June 24, 2024

To: Plan Holders for Improvements to the
KIRKSVILLE REGIONAL AIRPORT
KIRKSVILLE, MISSOURI
MODOT PROJECT NO. 24-028A-1

**ADDENDUM NO. 5
TO
CONTRACT DOCUMENTS, SPECIFICATIONS AND PLANS
FOR IMPROVEMENTS TO THE
KIRKSVILLE REGIONAL AIRPORT
KIRKSVILLE, MISSOURI
MODOT PROJECT NO. 24-028A-1**

A-002

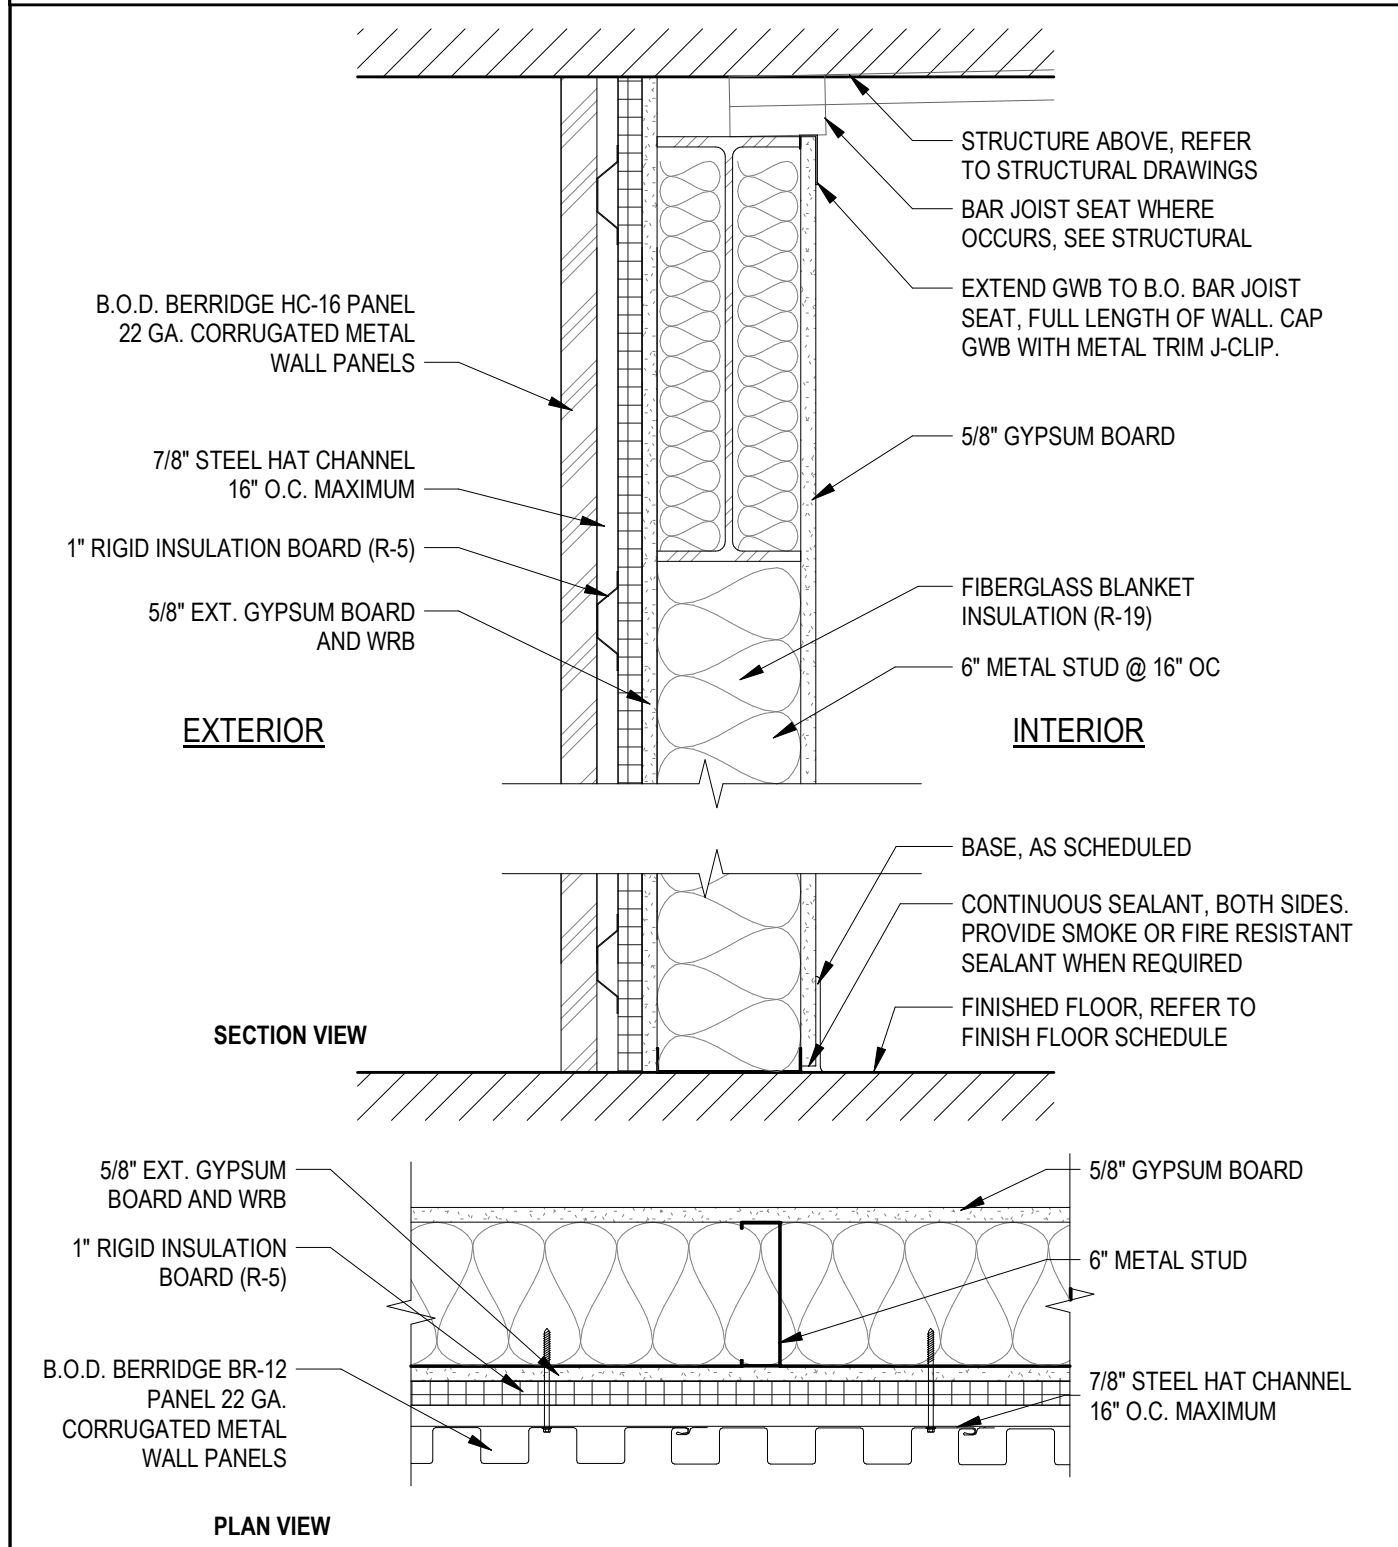
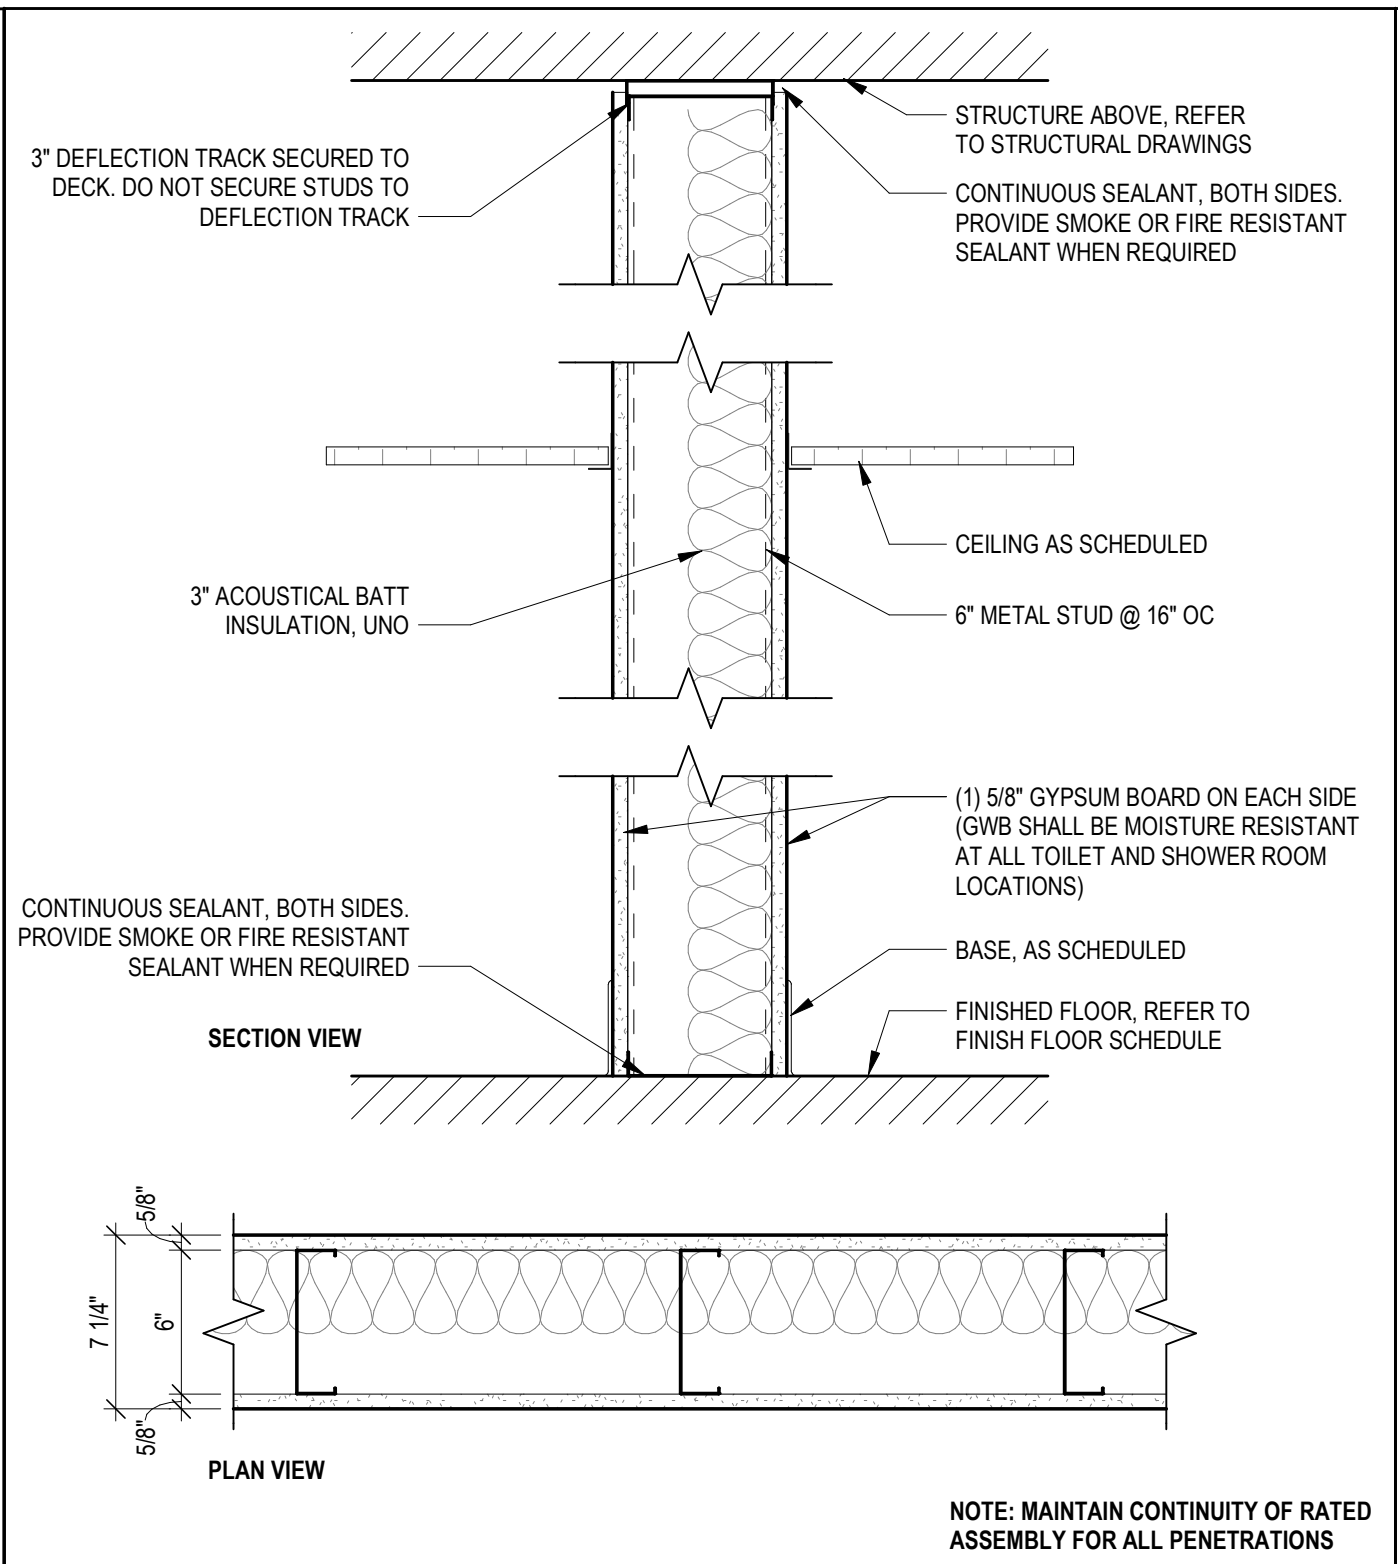
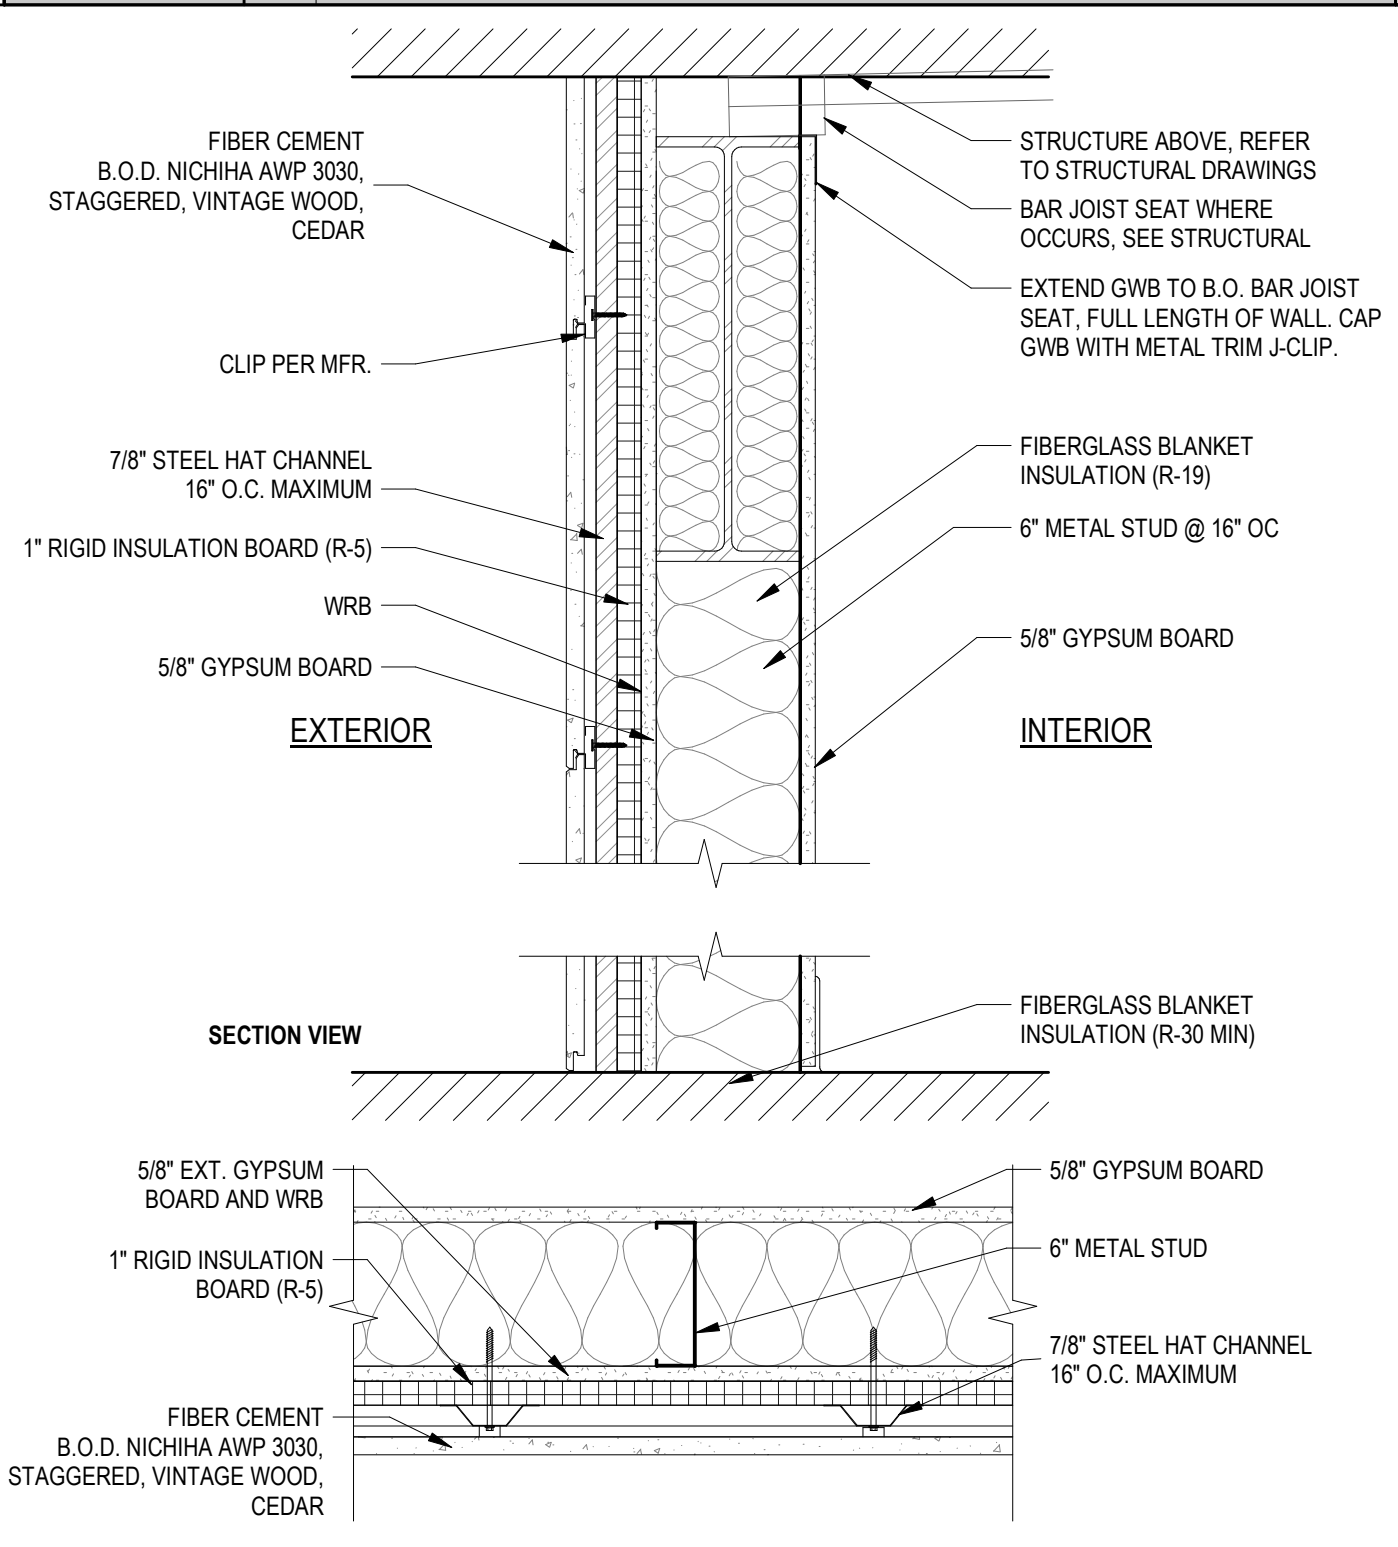
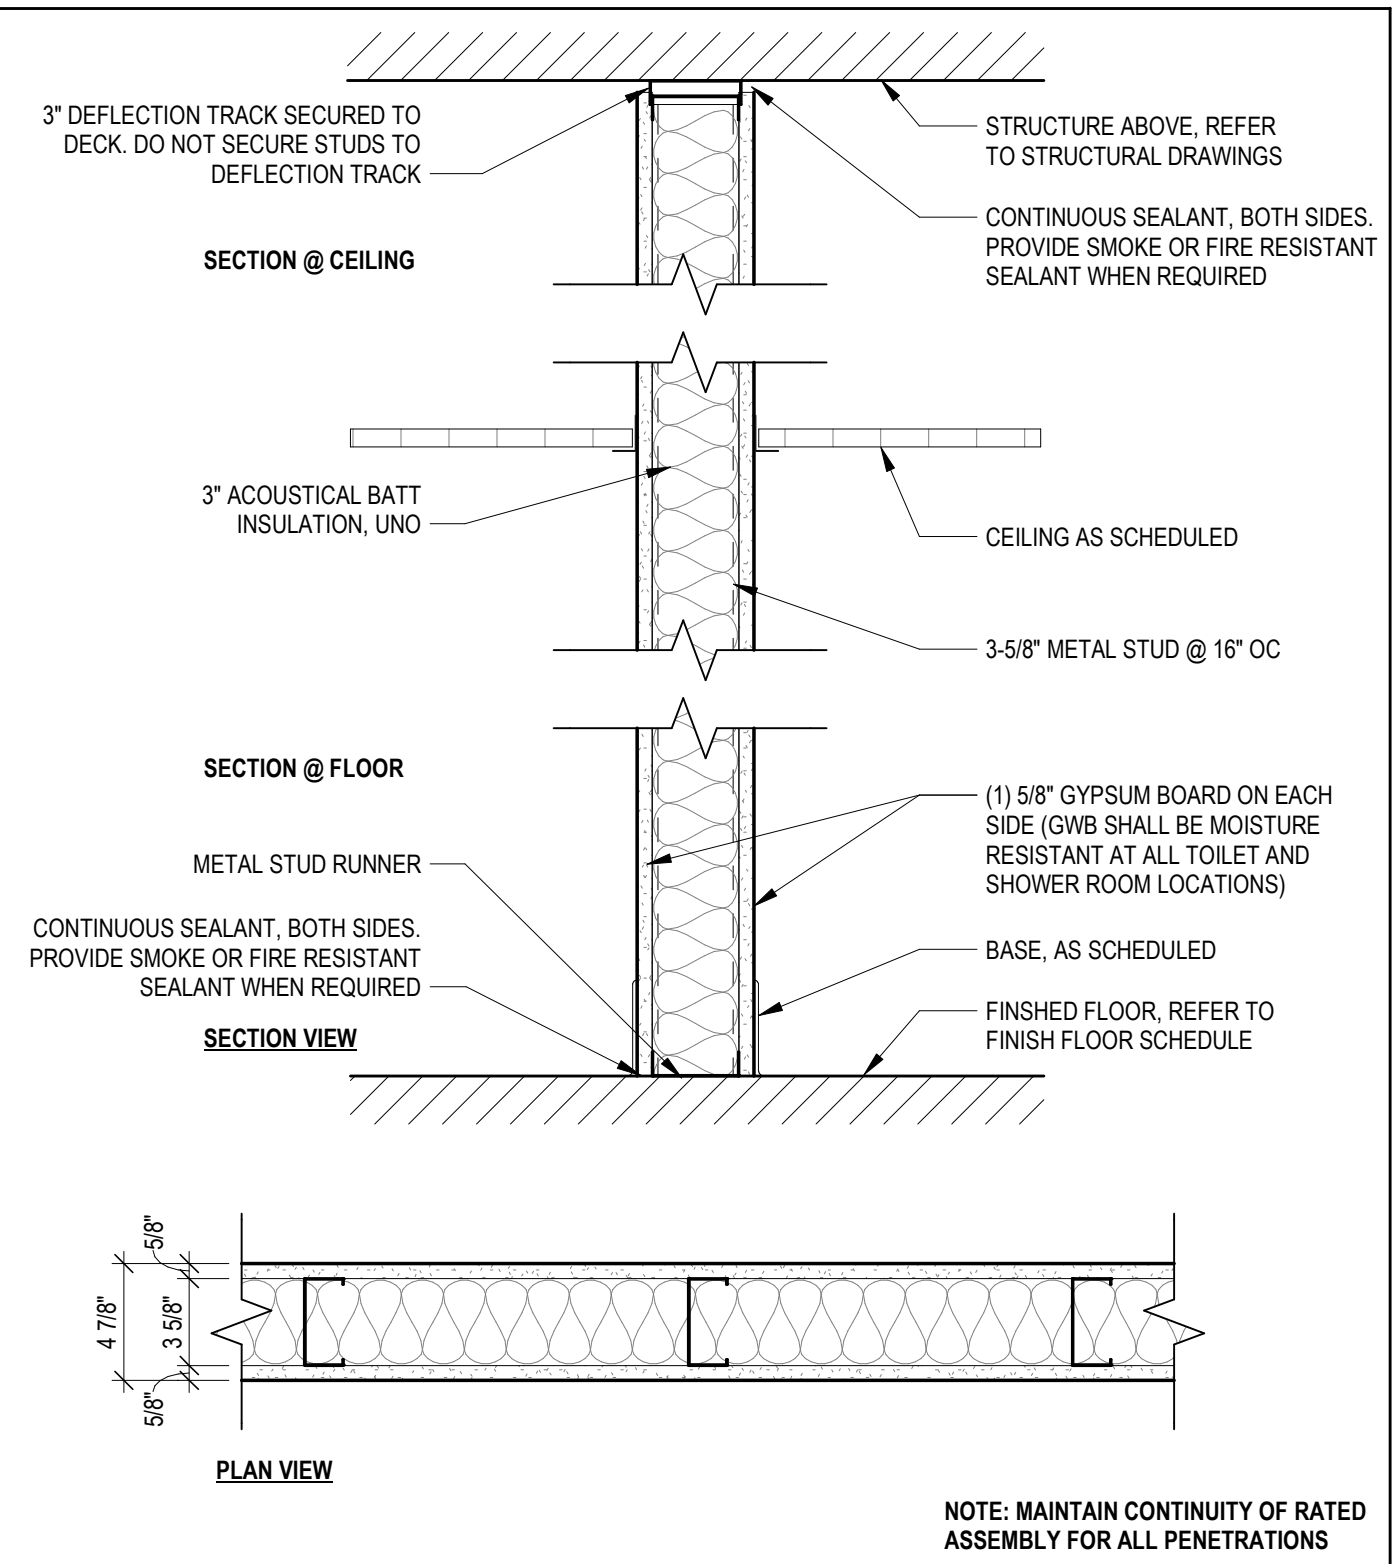
Sheet No.: A-002
Title: WALL AND ROOF/CEILING ASSEMBLIES
Revision: Revised Metal Roofing basis of design.
Justification: For clarity.
